# Optional 30K High-Current Trailer Cord Circuit Breaker Replacement

# 54-335

**Freightliner  
Service Bulletin**

Fig. 1, High-Current Circuit Breaker in the BCA Box

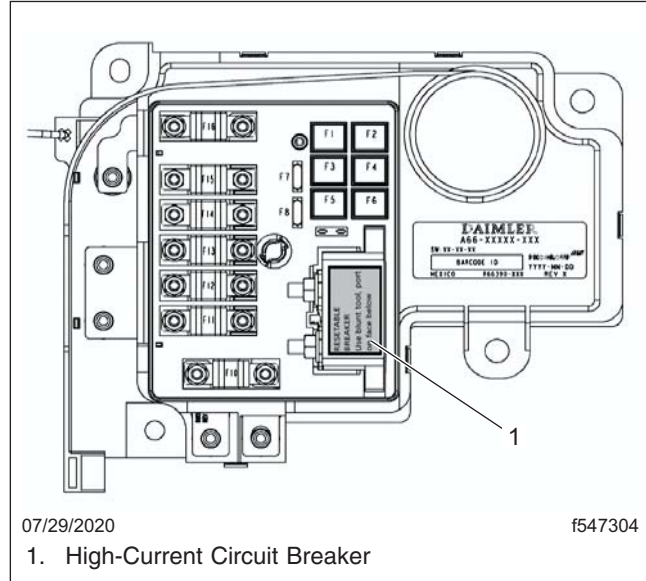
1. Park the vehicle on a level surface, shut down the engine, and set the parking brake. Chock the tires.
2. Disconnect the batteries.
3. Open the hood.
4. Remove the battery cable access (BCA) box cover. The BCA box is located on the right side of the cab front wall.
5. Locate the type I high-current circuit breaker in the BCA box. See [Fig. 1](#) and [Fig. 2](#).

6. Remove the two mounting nuts and remove the type I circuit breaker.
7. Install the new type III circuit breaker in the BCA.
8. Install and tighten the two mounting nuts to a maximum of 49 lbs-in (556 N-cm)

Fig. 3, Circuit Breaker With Label

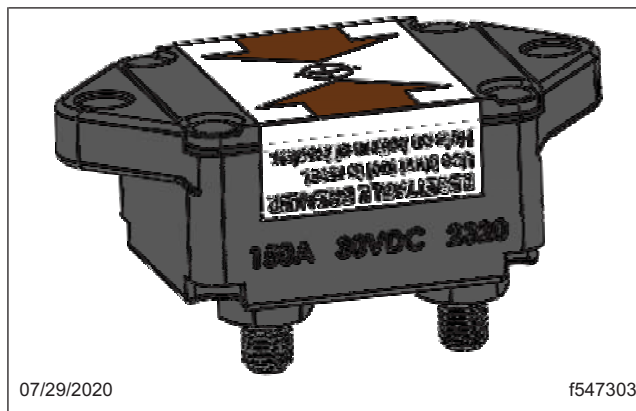
The type III manual reset circuit breaker comes with a label noting where the reset hole is located and how to reset the breaker using a blunt tool. See [Fig. 3](#).

**Fig. 4, High-Current Trailer Cord Used for Trailer Battery Charging**

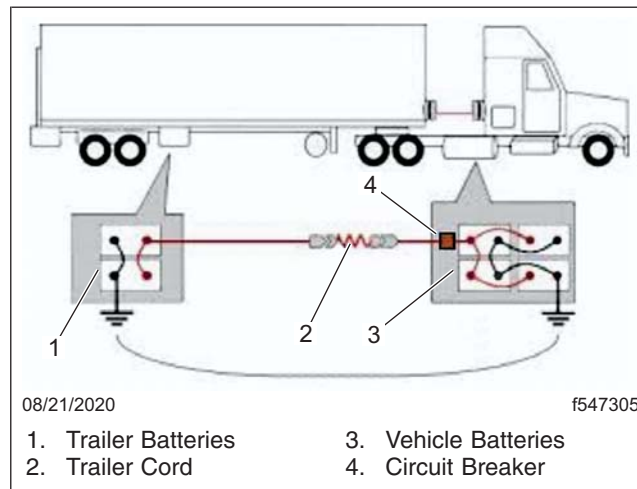
Due to current space constraints within the BCA, the type III circuit breaker does not have a visual indicator showing when the circuit breaker is open and needs to be reset.

In addition, the most common use of the high-current trailer cord is for trailer battery charging. This use can make it difficult to determine when or if the type III circuit breaker needs to be reset; when the cord is connected, trailer battery voltage can be present on one side and vehicle voltage can be present on the other. See [Fig. 4](#).

Unplug the high-current trailer cord from the trailer before checking to see if the type III circuit breaker is in an open or closed state.

With the trailer cord disconnected and vehicle voltage supplied to the circuit breaker, both studs on the circuit breaker should show voltage when the circuit is closed and not in need of a reset.

With the trailer cord disconnected and vehicle voltage supplied to the circuit breaker, if only one stud on the circuit breaker shows voltage, then the breaker has failed or needs to be manually reset.
